Lot 28
Phase North
Model Custom
ROSANNE & NICK CORTELLUCCI

Colours Upgrade Report
The Castles of King City Print Date:18-Jan-18

PE With Agreement
- Side/Rear Upgrade

- ADDITIONAL EXTRAS.
- UPDATED KITCHEN DRAWINGS

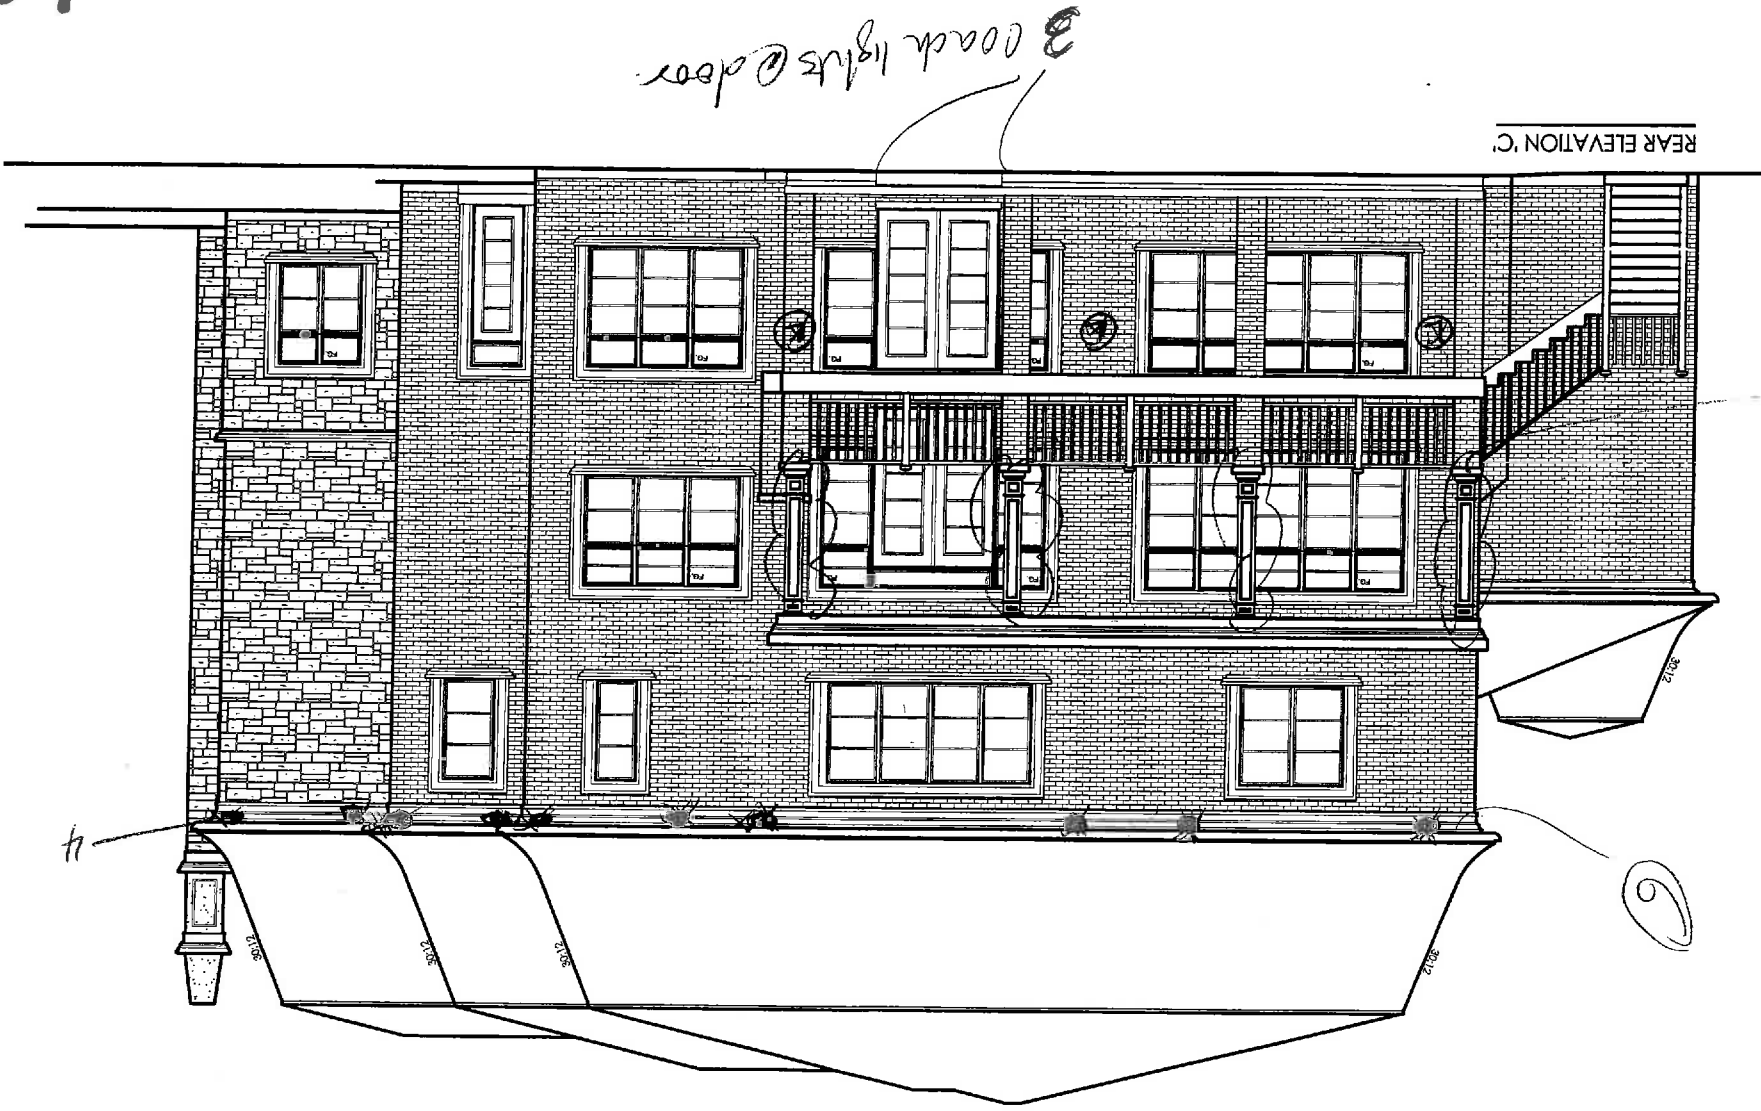
3 coach lights @ door

All brick

CLIENT: ZANCOR HOMES	JOB NAME: LOT 28 CKC	ROOM: KITCHEN	DRAWN BY: RP	COMMENTS: SINK WALL ELEVATION
SITE: CASTLES OF KING CITY	DOOR STYLE: —	DOOR HANDLE: —	SCALE: 1/2" = 1'-0"	
PHONE: —	FINISH: —	DRW HANDLE: —	DATE: DEC 4, 2017	
EMAIL: —	SPECIES: —	TOP: —	PAGE: 2/6

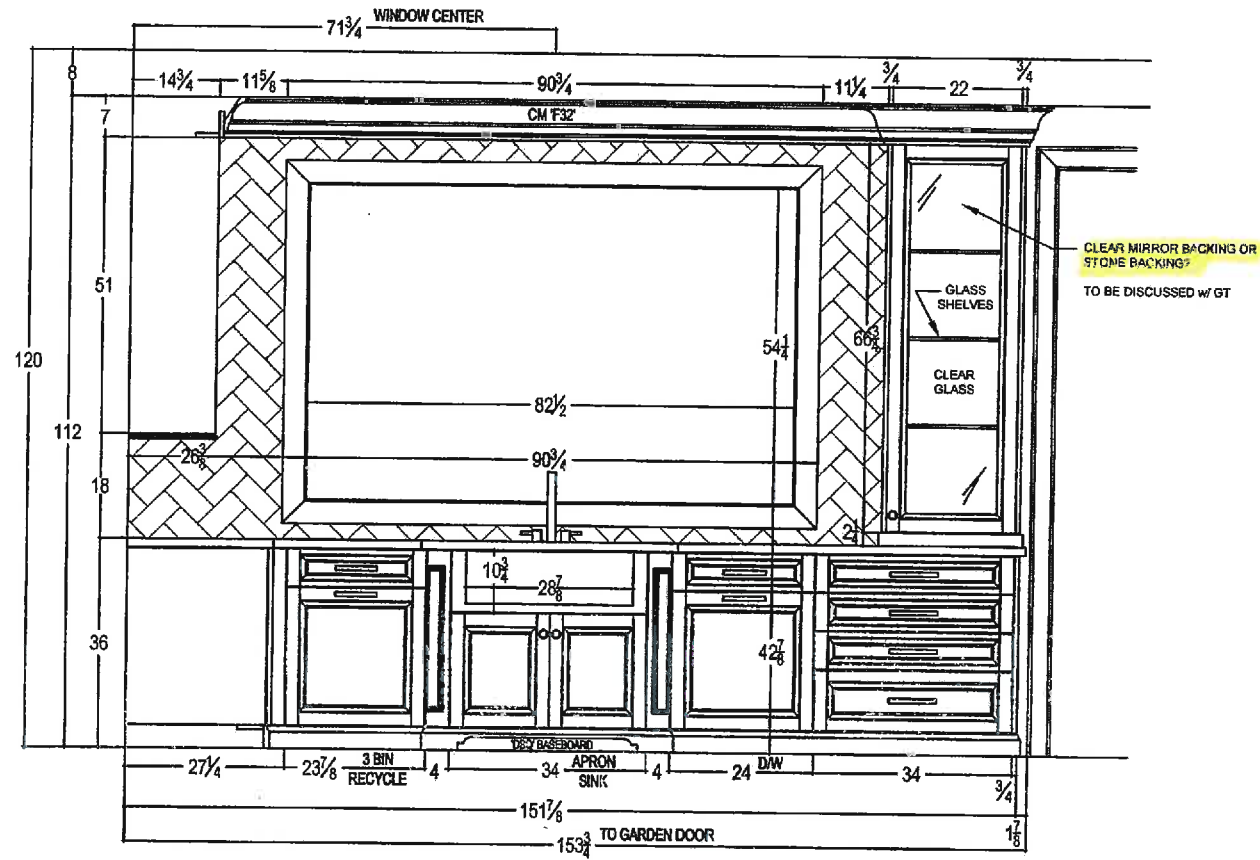
CLEAR MIRROR BACKING OR
STONE BACKING?
TO BE DISCUSSED W/ GT

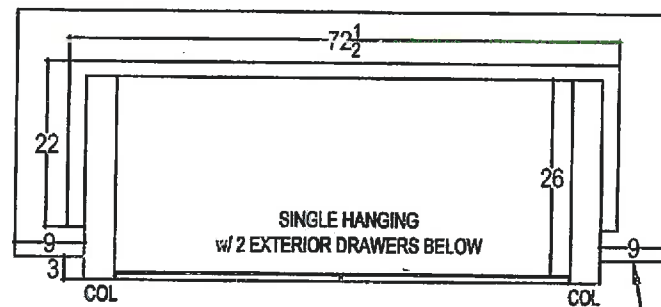
PACK OUT WALL
TO MATCH WITH
OTHER SIDE
